APPLICATION NO.	FILING DATE	FIRST NAMED INVENTOR	ATTORNEY DOCKET NO.	CONFIRMATION NO.
10/524,203	02/10/2005	Hiroaki Ozeki	MAT-8657US	9927
23122 RATNERPRES	7590 08/28/200 STIA	EXAMINER		
P.O. BOX 980	CE DA 10492	TIMORY, KABIR A		
VALLEY FORGE, PA 19482			ART UNIT	PAPER NUMBER
			2611	
			MAIL DATE	DELIVERY MODE
			08/28/2009	PAPER

Application No.	Applicant(s)					
	10/524,203	OZEKI ET AL.					
Office Action Summary	Examiner	Art Unit					
	KABIR A. TIMORY	2611					
The MAILING DATE of this communication app Period for Reply	ears on the cover sheet with the c	orrespondence address					
A SHORTENED STATUTORY PERIOD FOR REPLY WHICHEVER IS LONGER, FROM THE MAILING DA  - Extensions of time may be available under the provisions of 37 CFR 1.13 after SIX (6) MONTHS from the mailing date of this communication.  - If NO period for reply is specified above, the maximum statutory period w  - Failure to reply within the set or extended period for reply will, by statute, Any reply received by the Office later than three months after the mailing earned patent term adjustment. See 37 CFR 1.704(b).	ATE OF THIS COMMUNICATION 36(a). In no event, however, may a reply be time will apply and will expire

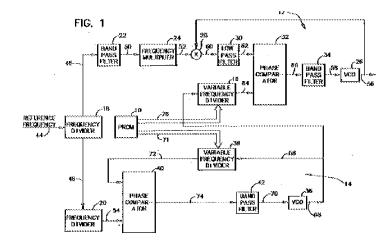
However, Paneth et al. in the same field of endeavor teaches a frequency divider (18 in figure 1) to divide a frequency of the first reference signal (44 in figure 1); a frequency multiplier (24 in figure 1) wherein an output frequency of the frequency multiplier (52 in figure 1) is a product of a multiplicand value (multiplying the frequency of the signal by nine is interpreted to be the multiplicand value) which is the divided frequency of the first reference signal (44 in figure 1) produced by the frequency divider (18 in figure 1) and a multiplier value (multiplying the frequency of the signal by nine is interpreted to be the multiplicand value) of the frequency multiplier (24 in figure 1) (col 3, lines 10-29).

However, Paneth et al. in the same field of endeavor teaches a low-pass filter (22 in figure 1) for receiving a signal output from the frequency divider (18 in figure 1) and outputting a signal to the frequency multiplier (24 in figure 1). Although, block 22 of figure 1 shows band pass filter, however, it would have been obvious to one of ordinary skilled in art to substitute the band pass filter with a low-pass filter to obtain a predictable result. Therefore, it would have been obvious to one ordinary skill in the art at the time the invention was

made to use the filter as taught by Paneth et al. to combine and modify the system and method of (AAPA) in order to minimize phase noise and electronic noise of the system (see col 1, lines 50-53).
